**Title:** SB 429-207 Bell 429 Condenser Fan Motor Mount Fastener Inspection

**Applicability:** Bell Helicopter Textron Canada Limited 429 Aircraft equipped with any Air Comm Corporation 429EC-200 or 429EC-202 Air Conditioning Systems. Not applicable to any 429EC-200 or 429EC-202 Systems with SK-429EC-7000 accomplished.

**Reference:** FAA STC # SR00693DE

Figure 1

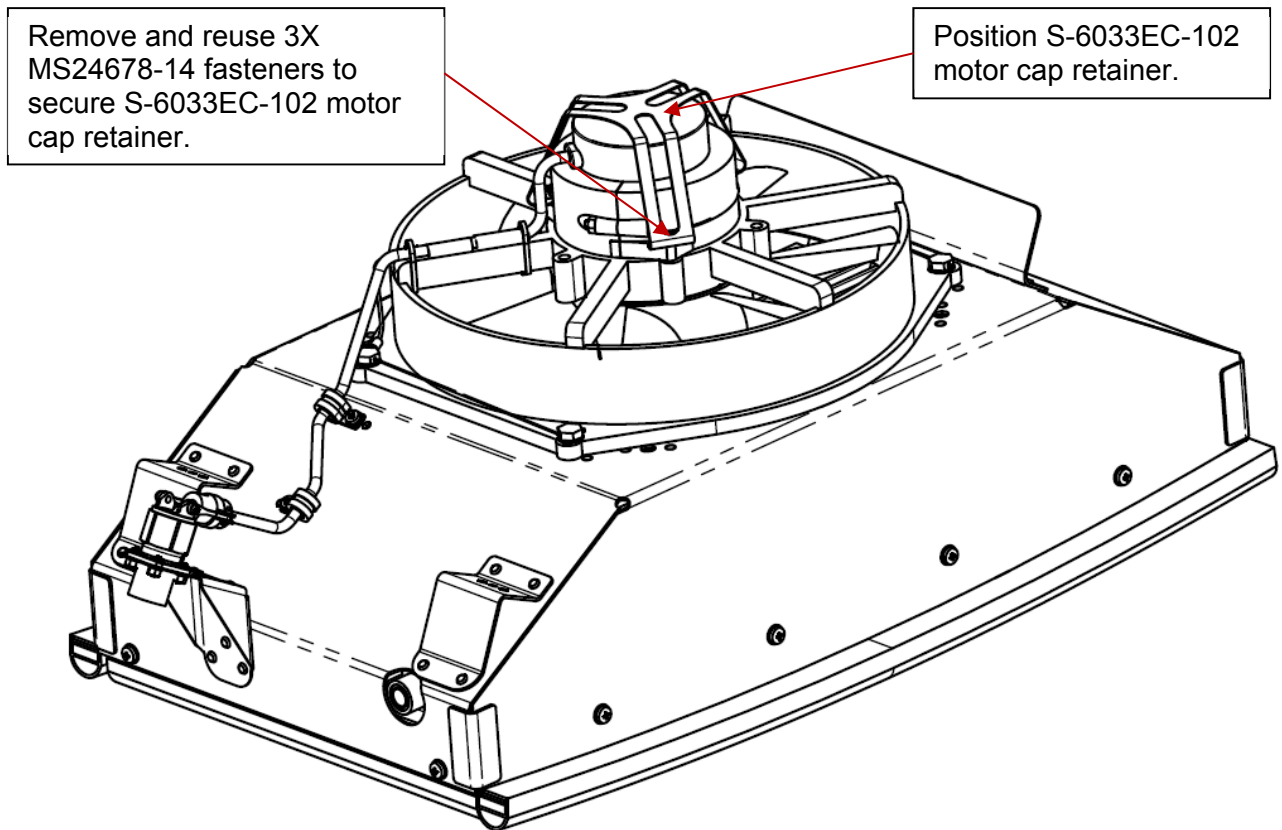
During a required inspection, an operator reported finding the blower motor cap detached from the motor body. This service bulletin was created to ensure safety of flight and to comply with all regulations. This bulletin adds an additional fan motor cap retainer to the assembly.

1. Verify SB 429-205 has already been conducted. Conduct SB 429-205 if it has not been conducted.
2. Remove the condenser assembly from the aircraft per 429EC-200M-1 Instructions for Continued Airworthiness.
3. Remove the 3X MS24678-14 fasteners and 3x washers securing the fan motor. The 3X MS24678-14 fasteners will be reused.
4. Discard the 3X washers.
5. Apply Loctite 222 to 3X MS24678-14. Install the S-6033EC-102 motor retainer as shown in figure 1 and figure 2, secure it using the 3X MS24678-14. Torque fasteners to 20-25 in-lbs.

**Figure 2**

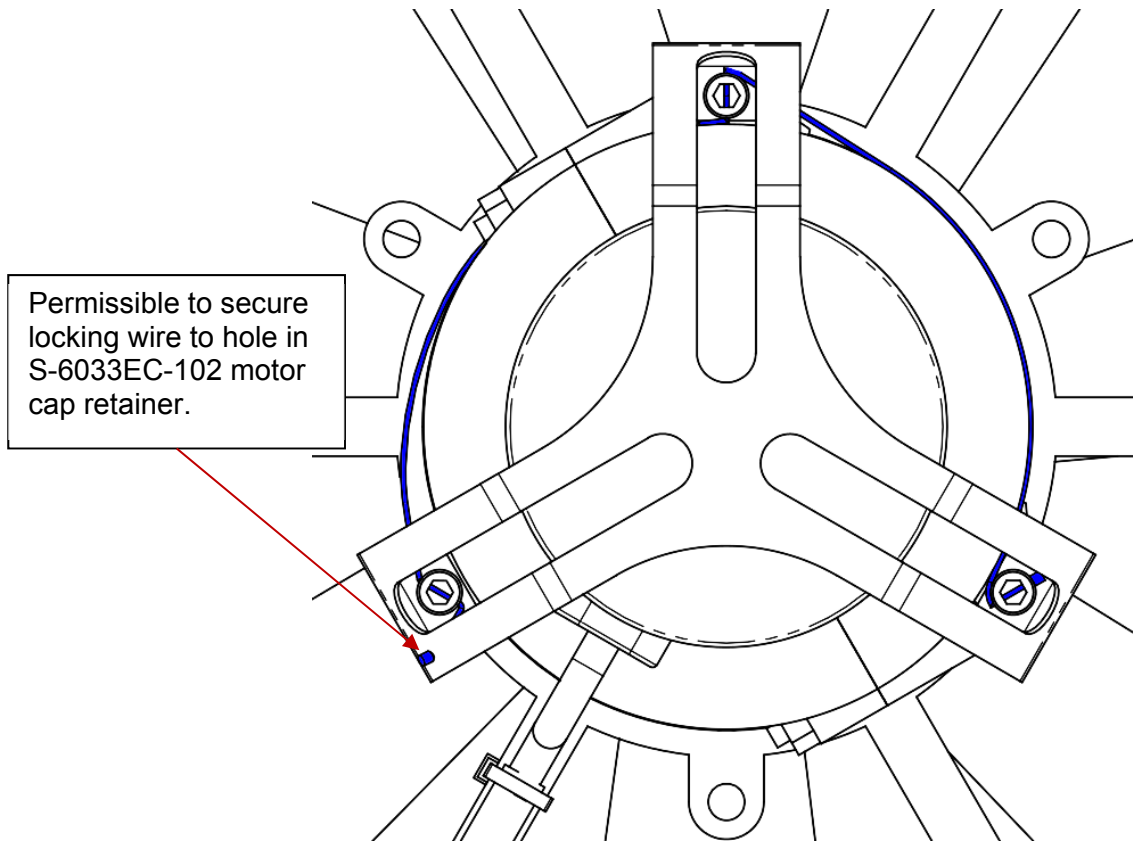
6. Attach AS3510-0224K locking cable or MS20995C32 locking wire to 3X MS24678-14 fasteners as shown in Figure 2, installing per the double-twist method specified in AC 43.13-1B Chapter 7 Section 7. It is permissible to use the small hole in the S-6033EC-102 motor cap retainer for securing the locking wire if the locking wire cannot be secured due to inaccessibility.
7. Mark blower using indelible ink with "SB 429-207 COMPLETED"
8. Reinstall the condenser assembly on the aircraft per 429EC-200M-1 Instructions for Continued Airworthiness.
9. Make log entry that this service bulletin SB 429-207 REV NC has been performed.
